Revision A: This document supersedes previous revisions.
Part 2- Reduction valve was #3826265, changed for #22416685

- PCJ OIL PRESSURE SENSOR REPLACEMENT
- PISTON COOLING REDUCTION VALVE REPLACEMENT
- ATS DOSER MODULE REPLACEMENT

Prevost vehicles

PART 1 - PCJ OIL PRESSURE SENSOR REPLACEMENT

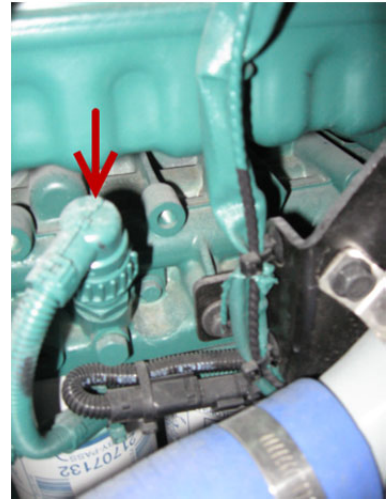
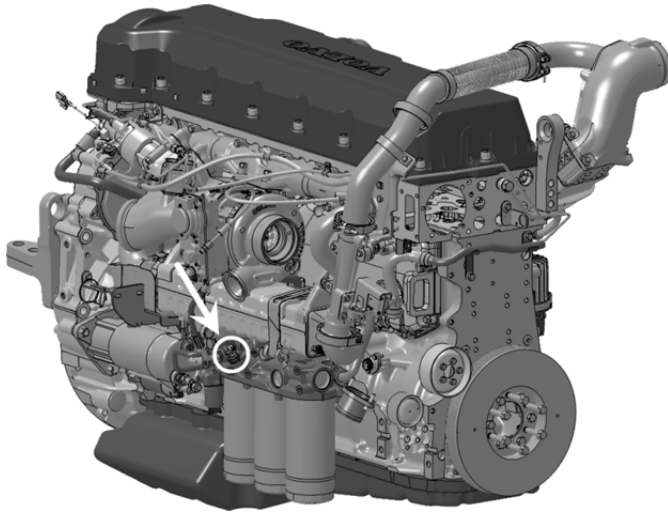
On the vehicles affected by this bulletin, the PCJ oil pressure sensor has to be replaced with an updated pressure sensor to avoid erroneous low oil pressure diagnostic codes.

- 1) Disconnect the PCJ sensor connector rotating the knurled collar counterclockwise. See the image below to locate the sensor.

- 2) Unscrew the sensor from the oil filter housing.
- 3) Clean out the electrical connector pins and sensor mounting surface with contact cleaner.
- 4) Install the new PCJ sensor (p/n 21634021). Torque: 18.5 ± 2 ft-lb.
- 5) Reinstall the connector and rotate clockwise to lock.
- 6) Run the engine and check for leaks.
